HISTORIC AND DESIGN REVIEW COMMISSION

February 17, 2016

HDRC CASE NO: 2016-048
ADDRESS: 701 W COMMERCE
LEGAL DESCRIPTION: NCB 299 BLK 24 LOT 1 THRU 14
ZONING: D H HS
CITY COUNCIL DIST.: 5
DISTRICT: Cattleman Square Historic District
LANDMARK: Maureaux Building, Toudouze Market & Buildings 2, 3 and 4
APPLICANT: Alyson Callison/210 Development Group
OWNER: Michael Wibracht/210 Development Group
TYPE OF WORK: Amendment to previously approved design/removal of Pecos street facade
REQUEST:

EXISTING W. COMMERCE ELEVATION

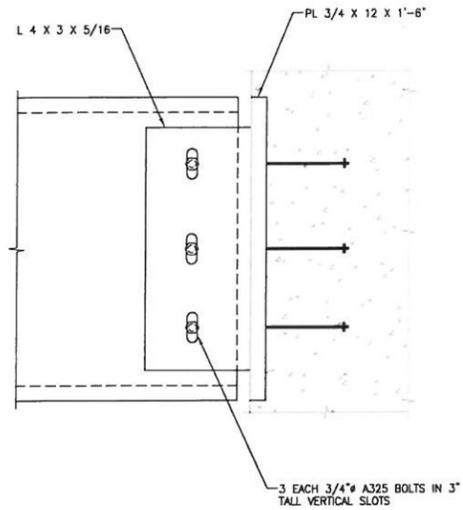
This is the area we are proposing to keep. The rest will not be salvageable. We will try to keep the corner, but it still may fall in TXDOT's right of way that they have not allowed us to work in.

Staff recommends approval of the rehabilitation of the E Commerce (south) façade and that the applicant restore both wall sections that resemble the E Commerce façade as noted in finding d. Additionally, staff finds that a salvaging plan be submitted for review that specifies the salvaging and reuse of brick from the section of wall that is to be removed throughout the new construction as noted in finding e.

1 EAST ELEVATION (PECOS STREET)

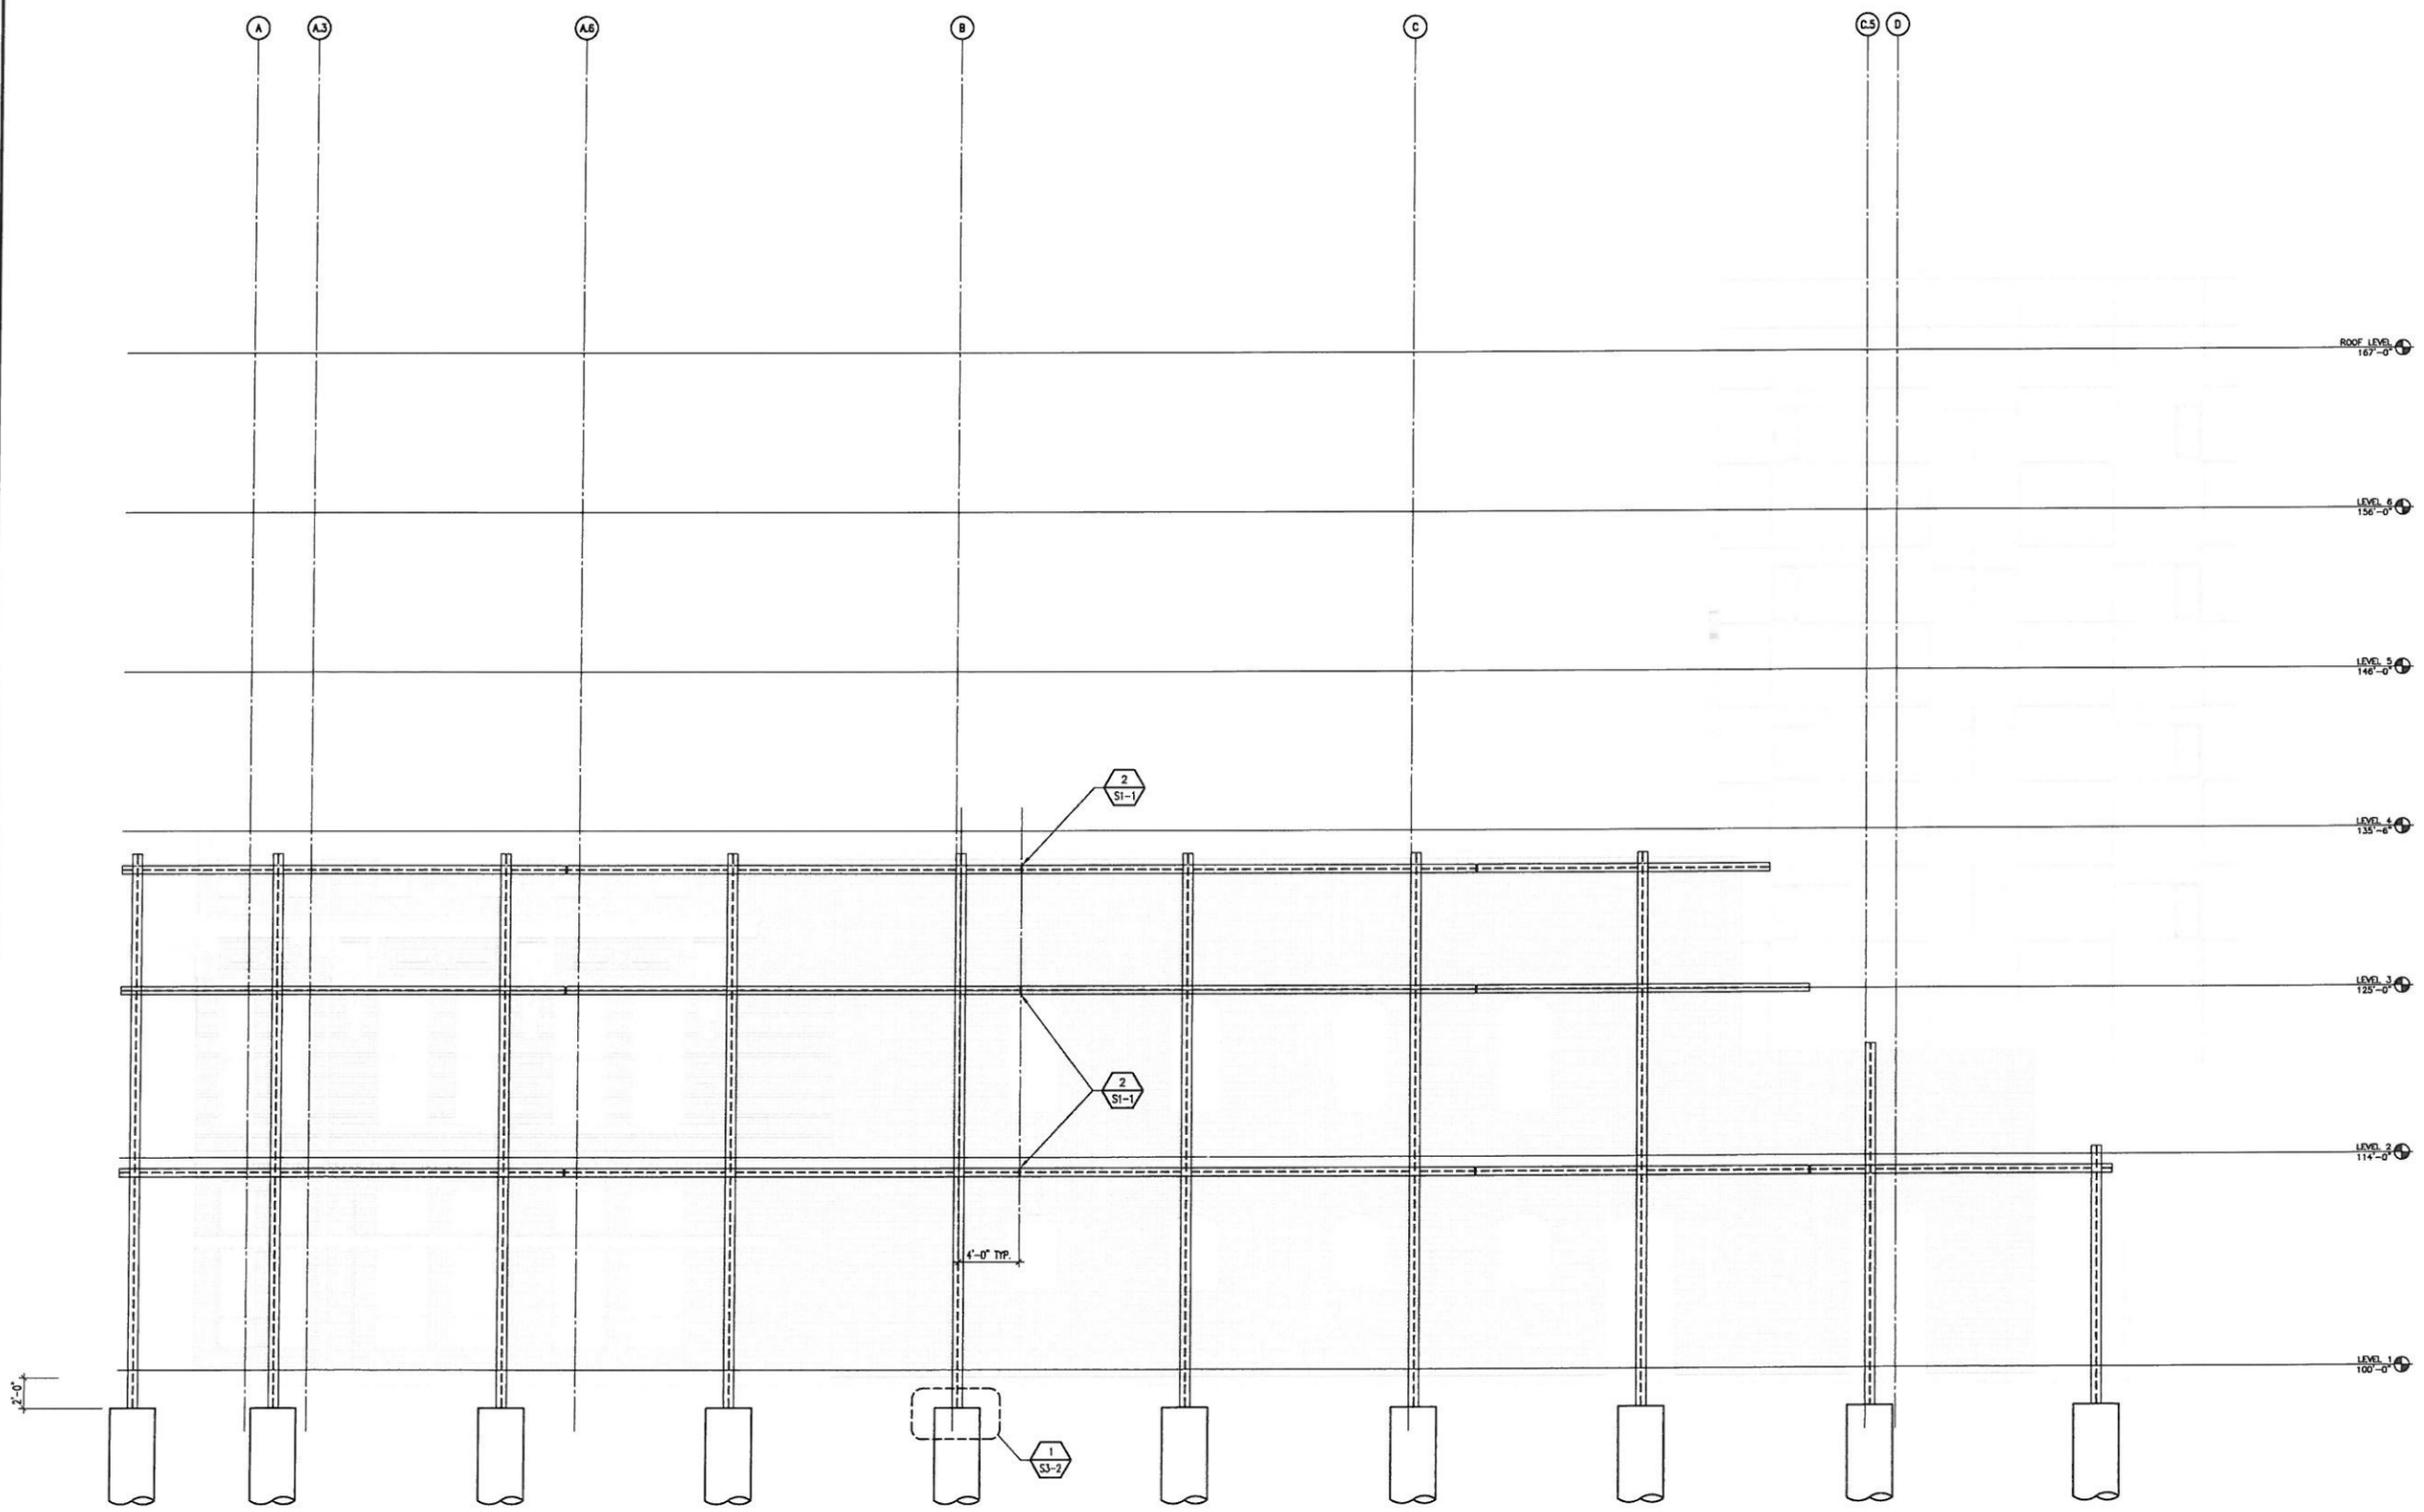
- d. At this time, the applicant has proposed to preserve only the façade that faces E Commerce (south). A 12.8 foot portion at the corner of E Commerce and Pecos as well as a 120 foot portion along Pecos are the two façade portions that the applicant has proposed to remove. All of the 12.8 section of wall that faces the southeast as well as approximately 35 feet of a portion of the 120 foot Pecos (east) wall feature ornamentation consistent with that of the E Commerce façade. The applicant's proposal to preserve the E Commerce street appropriate and consistent with the Guidelines, however, staff finds that the applicant should preserve the 12.8 foot section of the ornamental wall that faces southeast at the corner of E Commerce and Pecos as well as the approximately 15 to 20 foot section of the east facing wall on Pecos that extends to the first IH-35 support column. Both sections feature ornamentation consistent with that on the E Commerce façade.

Per HDRC's request to keep the facade of the Maureaux building, we hired Lundy & Franke to design a plan to do this (See attached). The plan was sent to TXDOT in December (see attached placement on site plan), since they own the right-of-way in front of the building because of the proximity to the highway. On January 13th, they denied the plan's overall design, stating the piers would interfere with the highway columns (see attached emails, and marked up plan by TXDOT). They also denied us access to use heavy equipment of any kind in their right-of-way.

Due to the response from TXDOT, not allowing us to access right-of-way and not allowing piers to be placed on the Pecos side of the façade, we are proposing only saving the historic facade that faces Commerce Street. We will try to salvage as many architectural details from the Pecos side of the building to be used at leasing office entrance/lobby area.

- e. Staff recommends the applicant develop a salvaging plan for the original brick along the Pecos (east) façade that will not be retained. Staff finds this brick should be reused in the project. Because this portion of the building is under the overpass and not very visible, staff finds that it may be more meaningful to incorporate the brick into other facades with more visibility. This should be provided to staff along with construction documents that note the preservation of all ornamental walls as mentioned in finding d prior to the issuance of a Certificate of Appropriateness.
